23 August 2022

Re: National Trust objection to Barangaroo Concept Plan - Modification 9

Figure 2: The relationship between Barangaroo Central and the Millers Point Conservation Area (red) and the Millers Point and Dawes Point Village Precinct (yellow) is clear to see in this image. (Source: Infrastructure NSW with National Trust overlay).

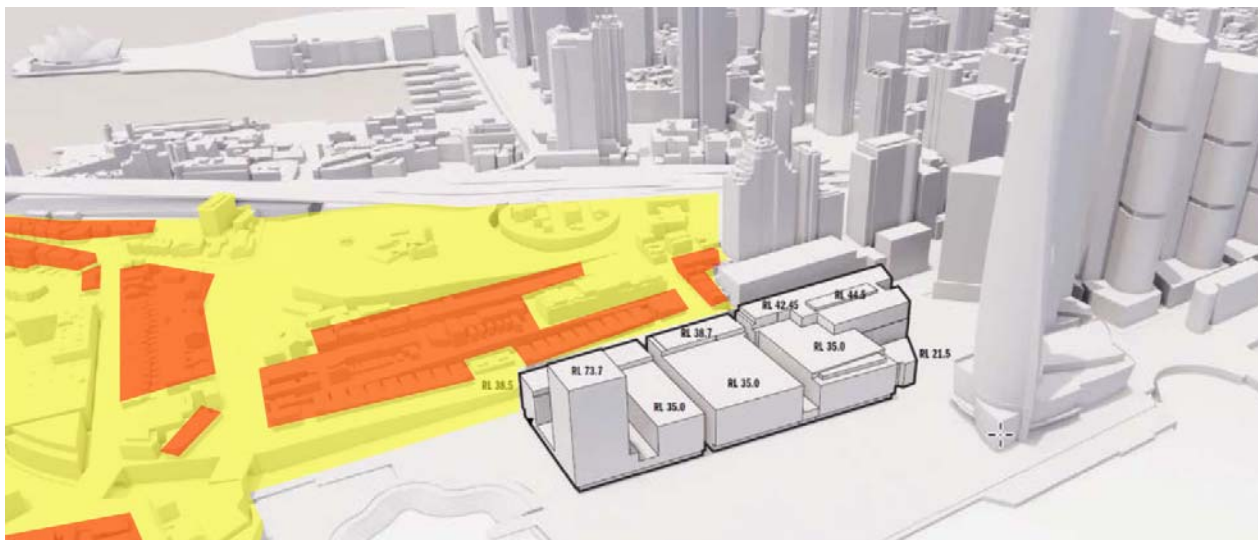
Located adjacent to Millers Point and Dawes Point, within the viewshed of Observatory Hill, the Sydney Harbour Bridge and suburbs located to the west, north west and south west, the single greatest asset that Barangaroo Central has above the earlier components of the entire Barangaroo development is the heritage nature of this location, and the ability to integrate in a meaningful way with the existing community of Millers Point and its residents, businesses, churches, schools, pubs and restaurants.

The heritage significance of this place is well established through its listing on the State Heritage Register as the *Millers Point Conservation Area* and the *Millers Point and Dawes Point Village Precinct*. These areas, precincts, places and views have been long identified, recognised, protected and conserved, as outlined in the table below.

Figure 8: Proposed building height increases across the three blocks.

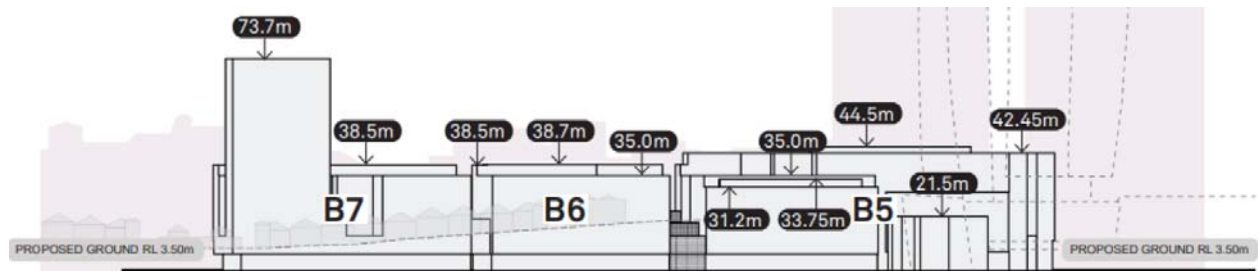
Modification 9 proposes to increase the heights of the 3 Central Barangaroo blocks; it should be noted that ***all previous modifications*** kept the building heights consistent with the approved Concept Plan.

These increased heights represent a significant, large scale change to the approved concept design, as shown in the Figure below.

The Proposed Modification 9, which incorporates a tower on the north-west corner of Central Barrangaroo, fails to adequately acknowledge and assess its impact on views:

- from and to Observatory Hill;
- from and to Millers Point Precinct; and
- to the Harbour Bridge.

The 70m tower, shown in Figure 9, is located in the highly prominent NW corner of the site. **This location is totally unacceptable for a tower and cannot be justified in urban design terms.** Height alone does not, and never has, given prominence or design quality to a building. As the yellow arrow indicates, this building will directly block the western views to and from Sydney Observatory and Observatory Hill.

- The tower is removed from the proposal;
- The heights of all buildings, as a minimum, be lowered to the approved concept heights (February 2007 approval);
- An accurate view impact analysis, including views from High Street and from the water itself, is produced to show the full impact of the proposal.
